LONG-TERM MONITORING NETWORK

OPTIMIZATION EVALUATION

OPERABLE UNIT 2

BUNKER HILL MINING AND METALLURGICAL COMPLEX

FIGURE 2.1
OU2 SITE FEATURES

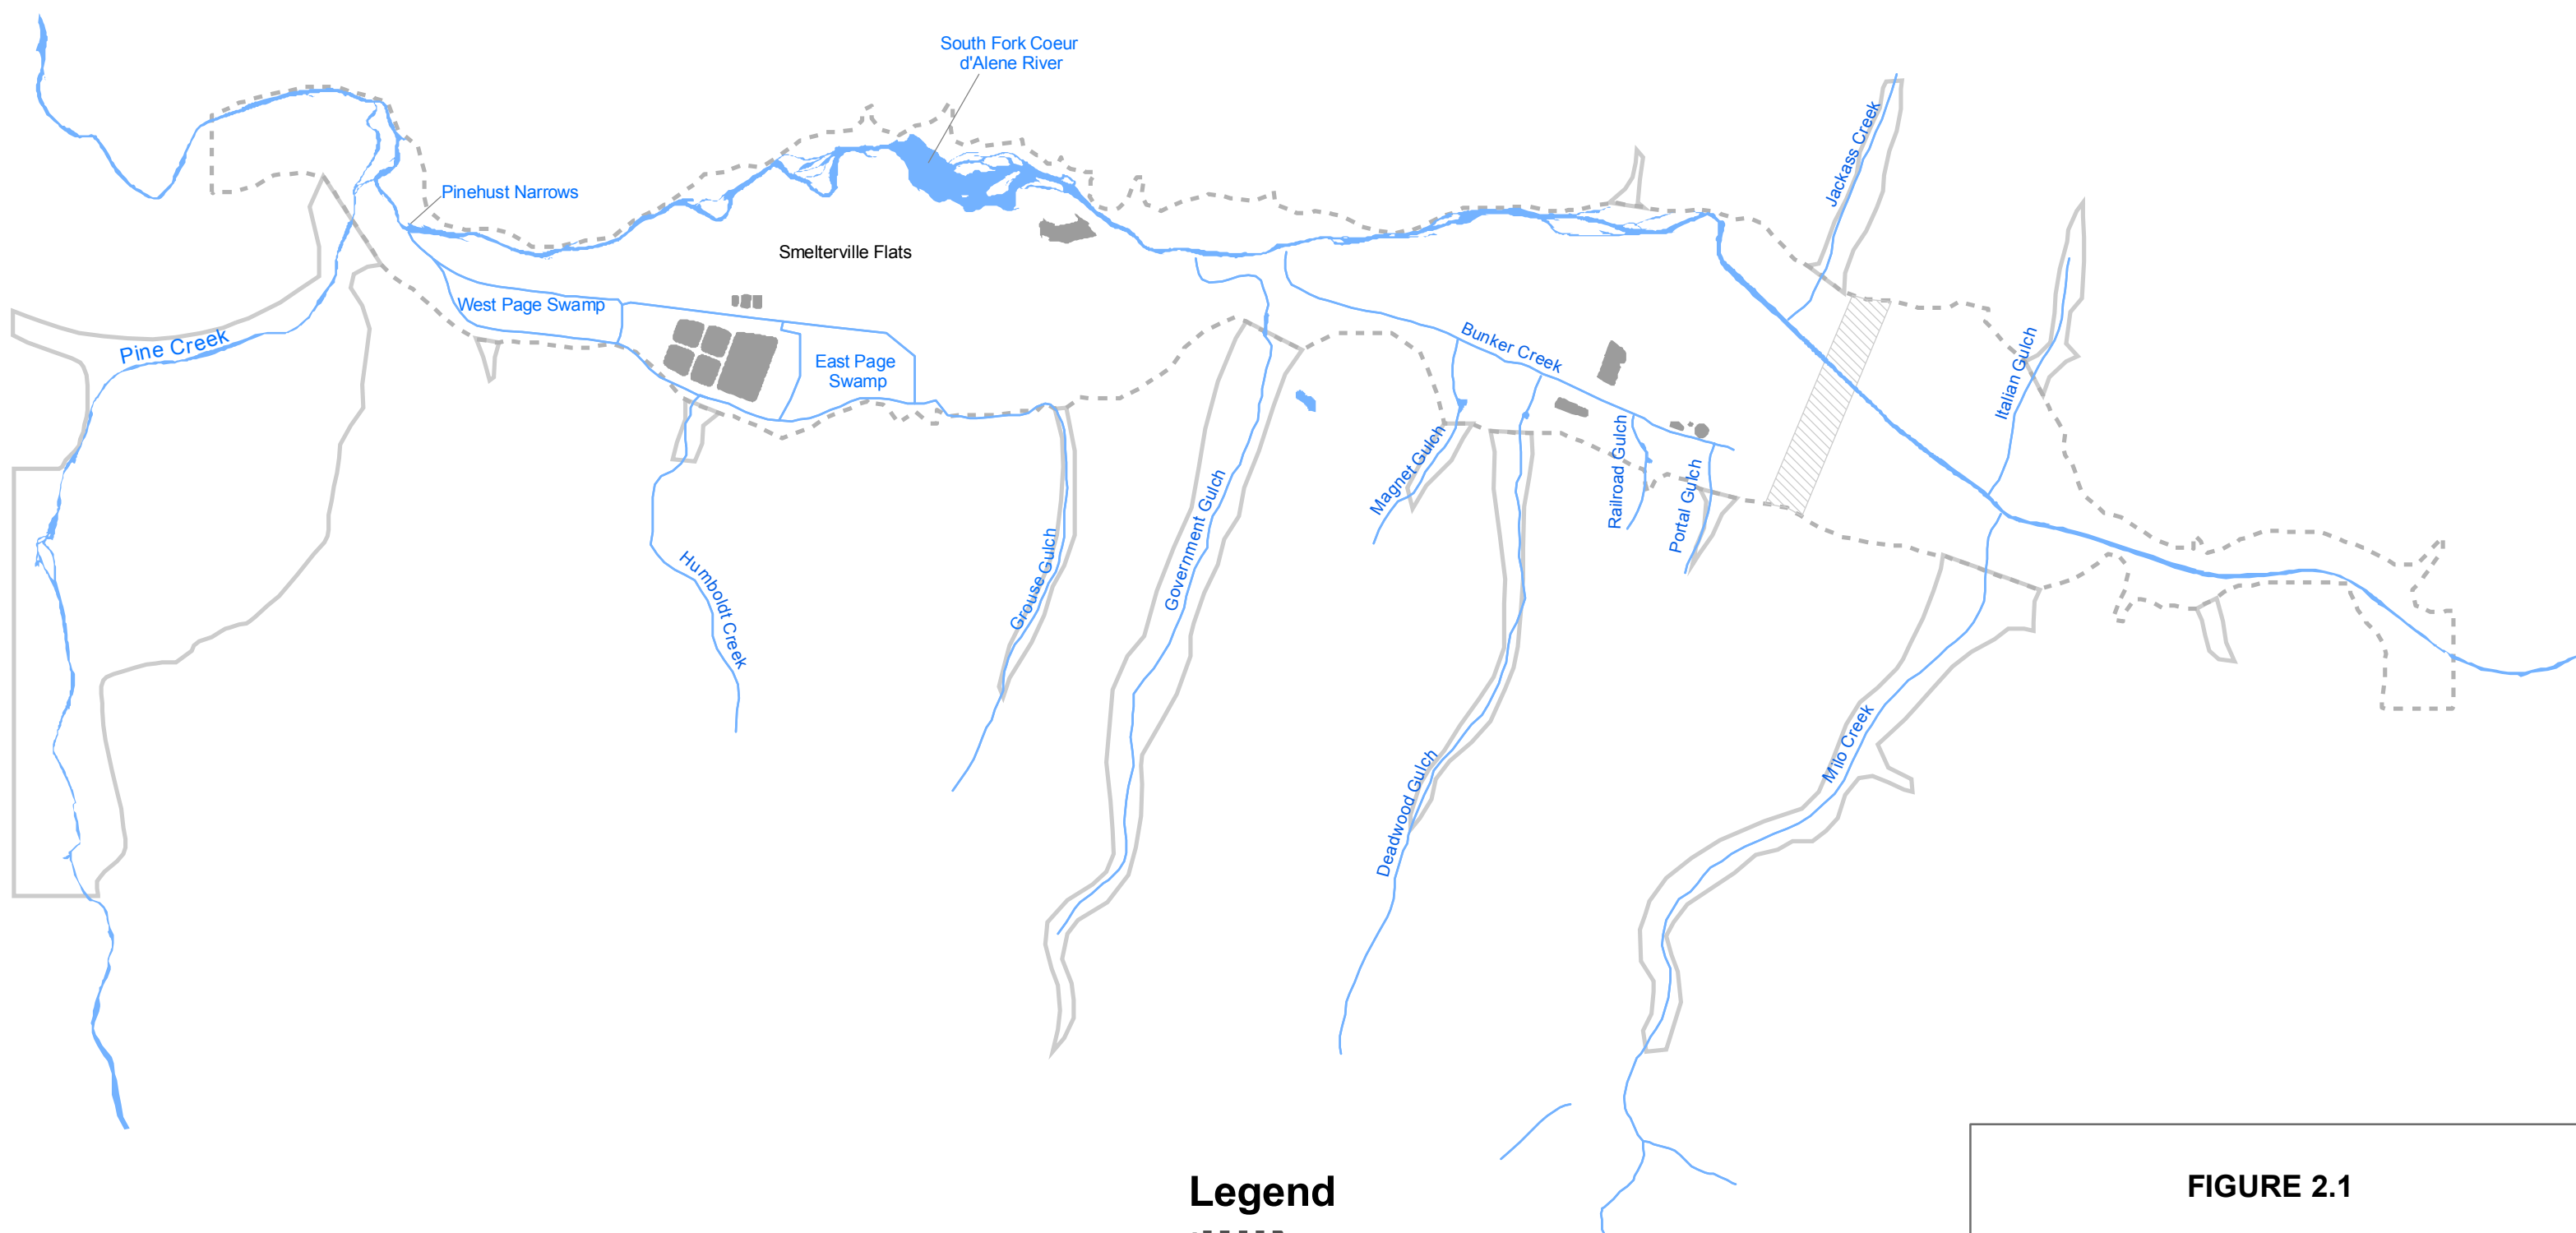
Item No.	Section/Page	Line(s)	Comment	Response
1.	Title		It would alleviate a potential source of confusion to add Operable Unit 2 to the title.	Done.
2.	Figure 2.1		The confining unit box shown in this figure and others within the report should be identified as the approximate eastern extent of the confining unit.	Done.

FIGURE 3.7
MOST RECENT TOTAL AND DISSOLVED ARSENIC IN SURFACE WATER
LONG-TERM MONITORING OPTIMIZATION
BUNKER HILL MINING AND METALLURGICAL COMPLEX

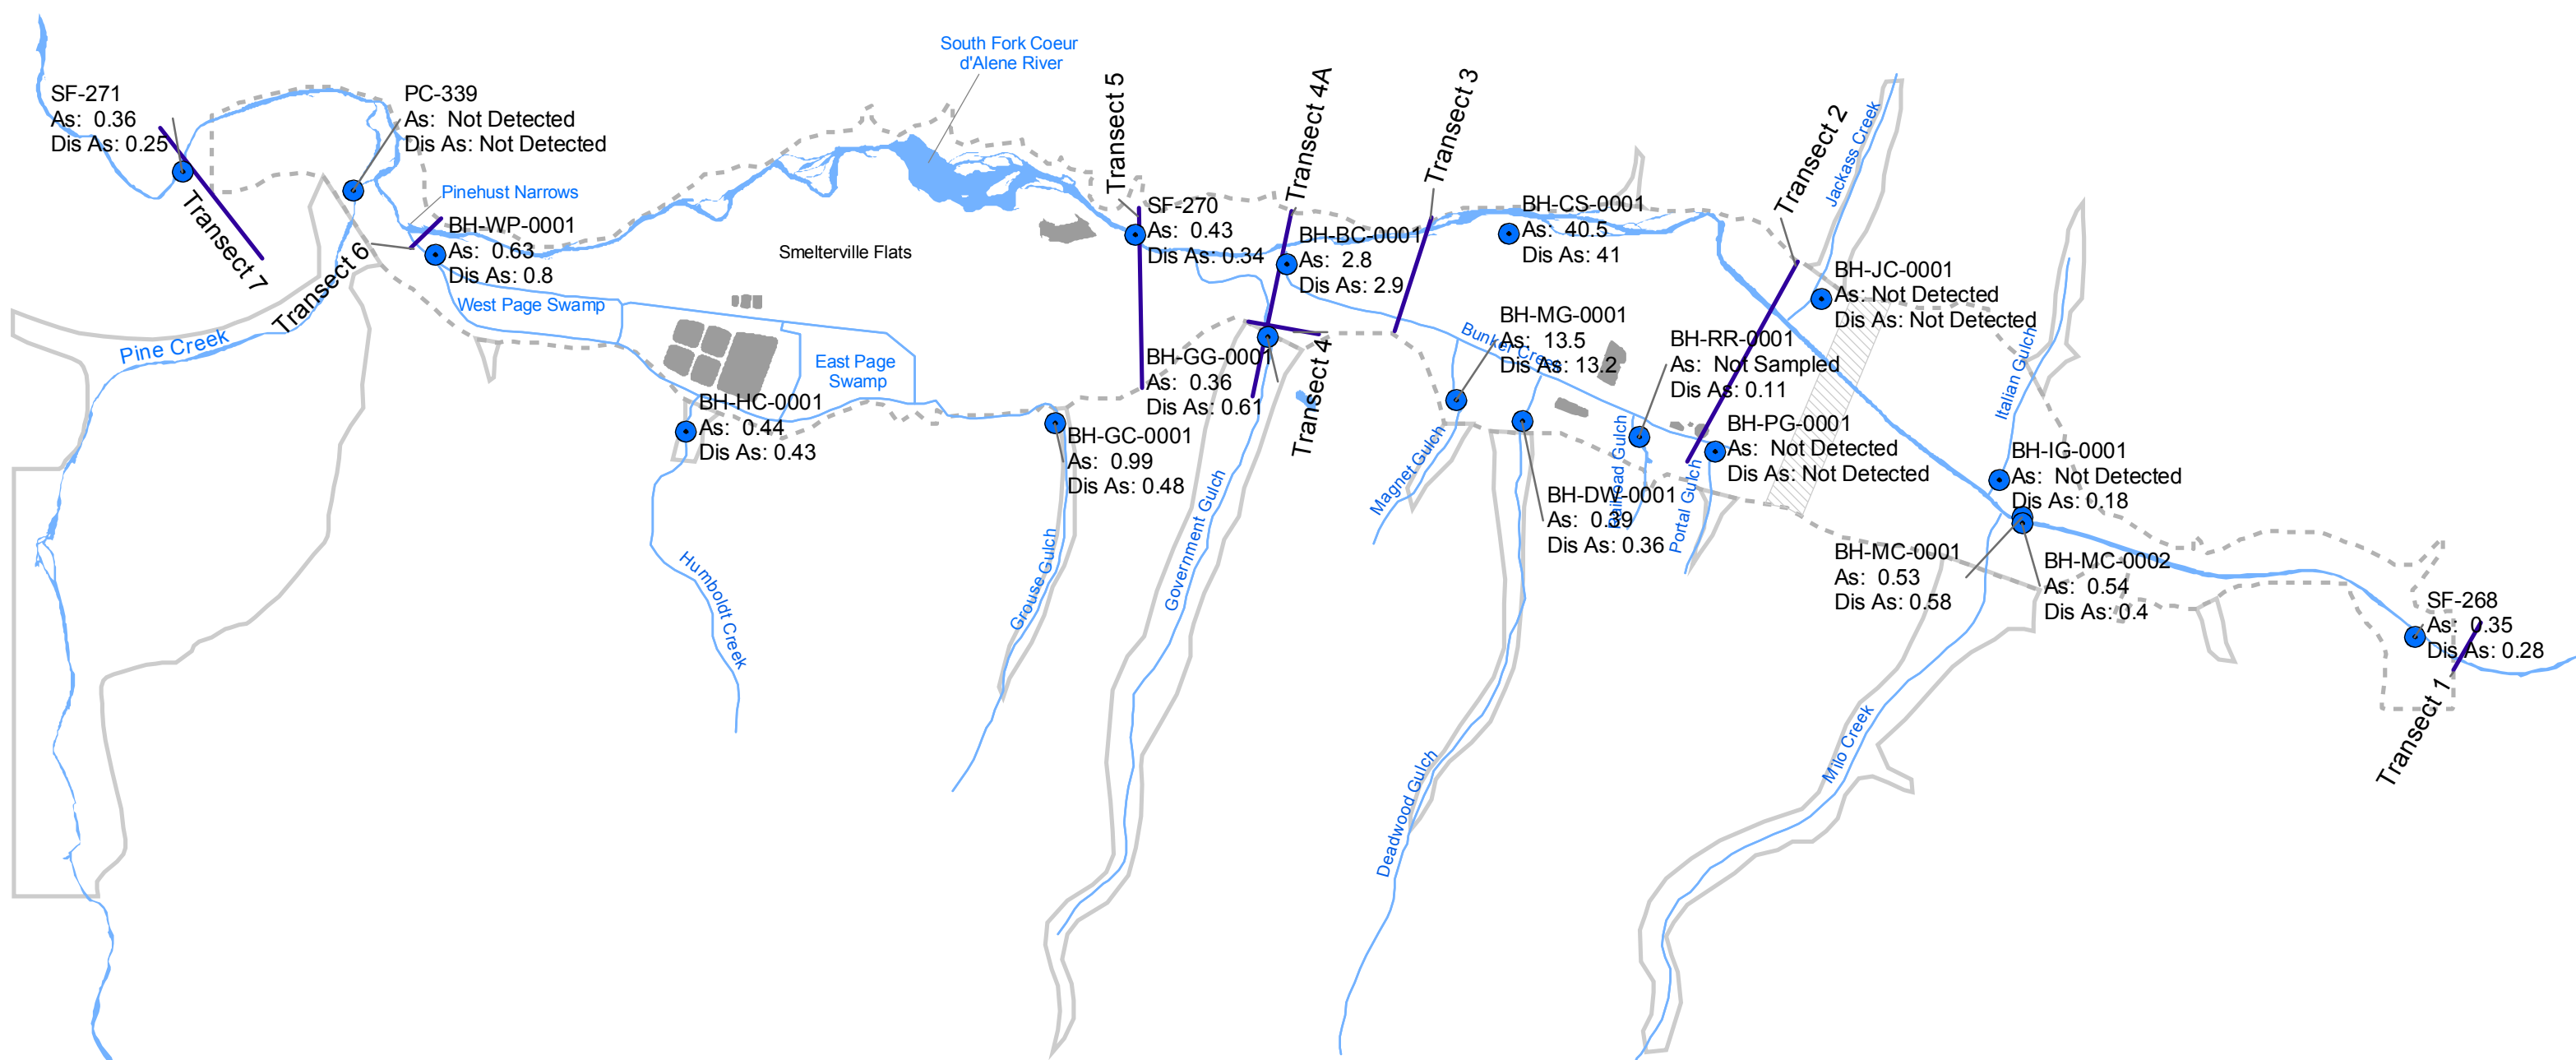
3.	Page 3-19	Figure 3.7 and subsequent figures	Some of the posted values are the same for several sampling points. Please verify the values. Are these detection limits?	The figures were revised to display non-detects as "ND" and to post the correct COC data (corresponding to Table 3.6).

FIGURE 5.4
TEMPORAL TREND DECISION RATIONALE FLOWCHART
LONG-TERM MONITORING NETWORK OPTIMIZATION
BUNKER HILL MINING AND METALLURGICAL COMPLEX SUPERFUND SITE

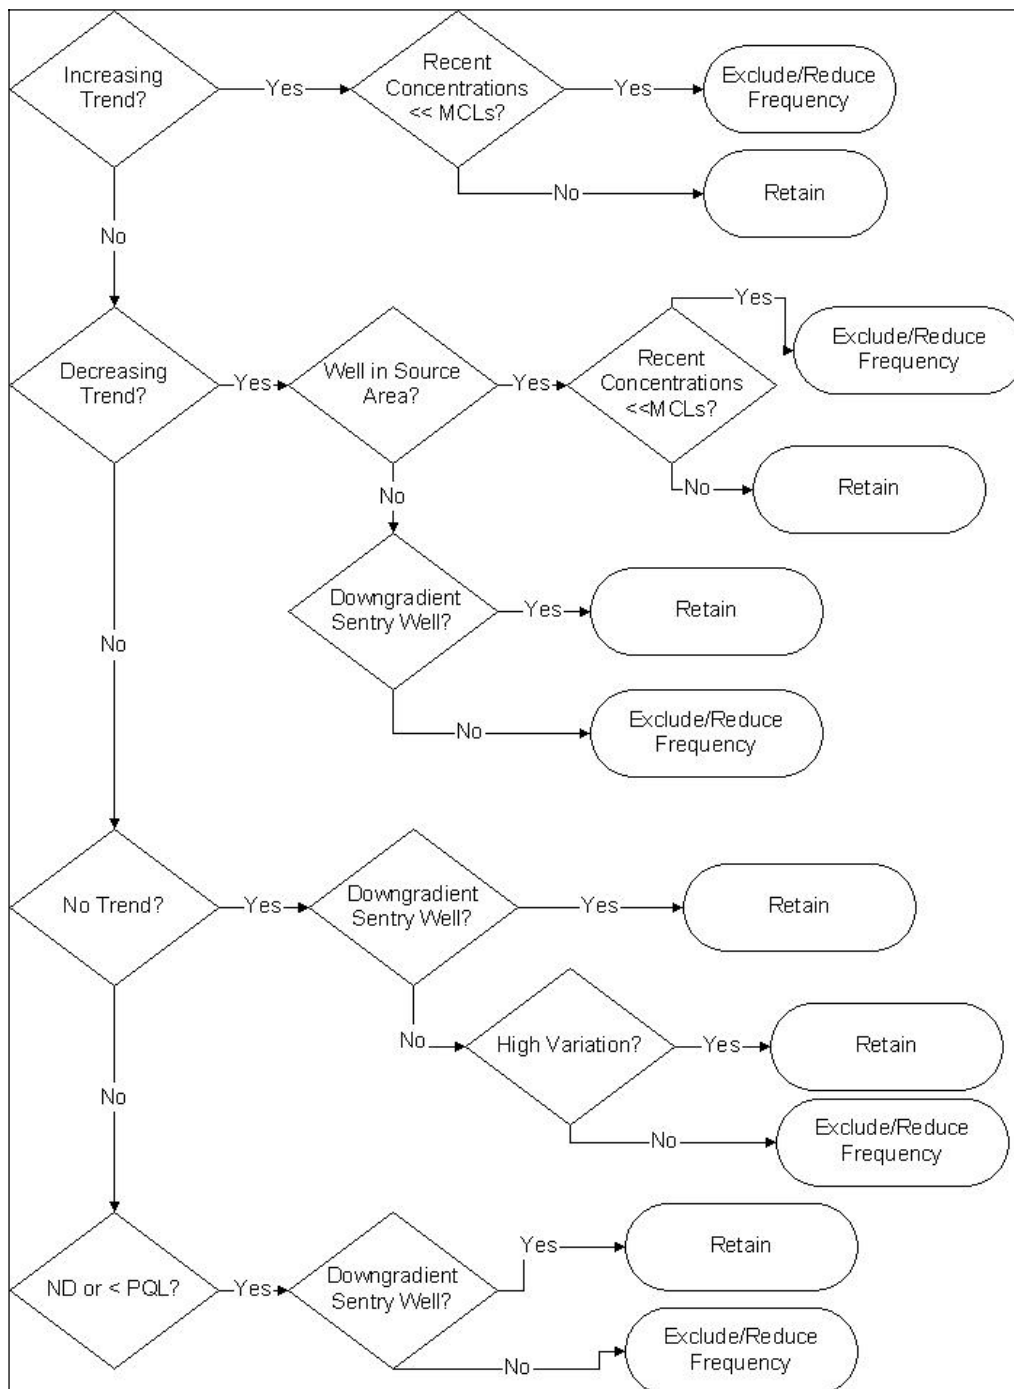
2.	Figure 5.4	What is the criterion for the box labeled “high variation”?	High variation = coefficient of variation > 1 (consistent with MAROS). Footnote added to table and explanation added to text.

41.	Figure 5.4		Interesting but does not fit the OU2 area because metal sources exist over most of the area.	Although the Bunker Hill site does not fit the typical mold of a groundwater monitoring site, the temporal trend flow chart still is applicable because (as indicated in the comment) most wells were classified as “source wells” (as shown in Table 5.1) and temporal recommendations were made on that basis.

FIGURE 7.2
COMBINED EVALUATION SUMMARY DECISION LOGIC
LONG-TERM MONITORING NETWORK OPTIMIZATION
BUNKER HILL MINING AND METALLURGICAL COMPLEX

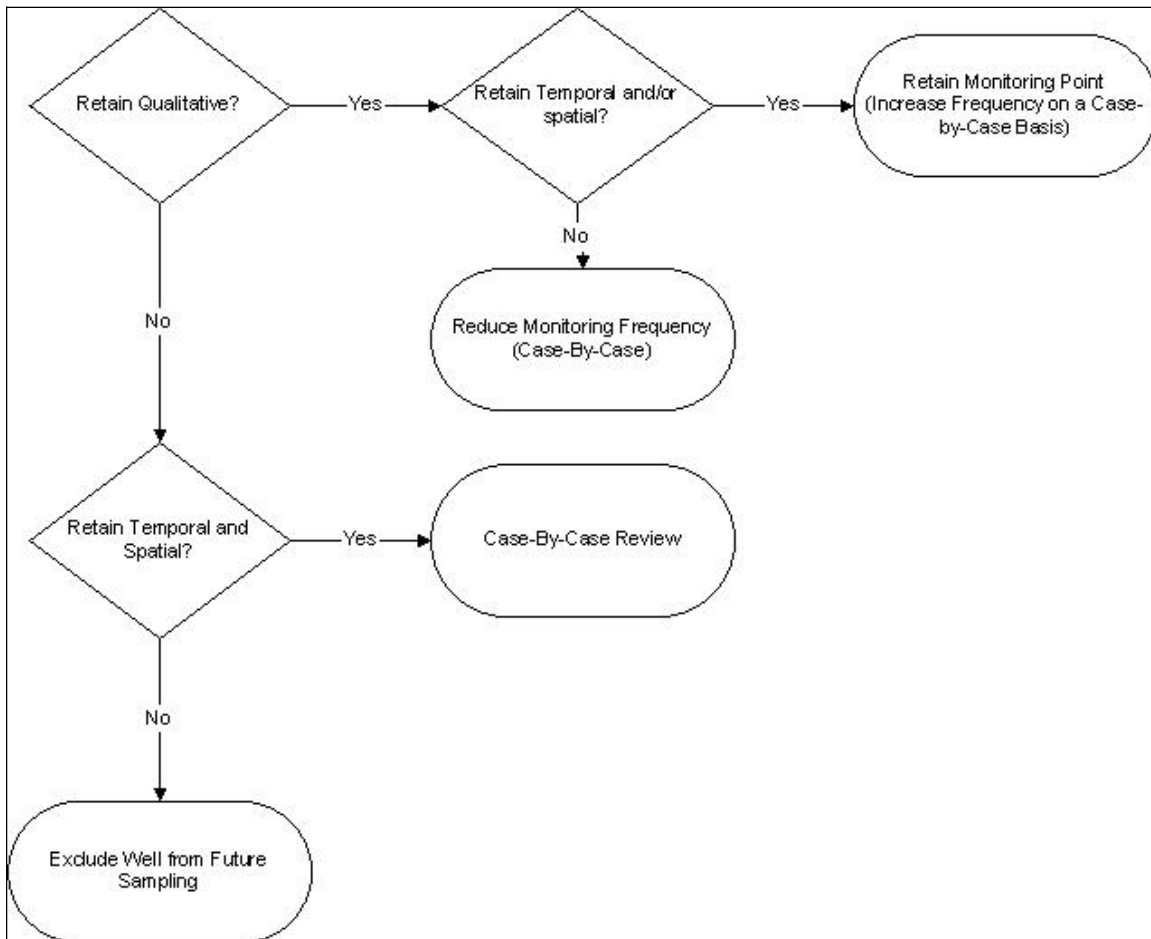
11.	Page 7-2	Table 7.1	Please show the recommended additional wells in this table.	New wells added to summary table.
12.	Page 7-6	Figure 7.2	Again, please indicate the potential to increase sampling frequency for increasing trends in downgradient wells if the current frequency is not adequate.	Increase frequency option added to flow chart.
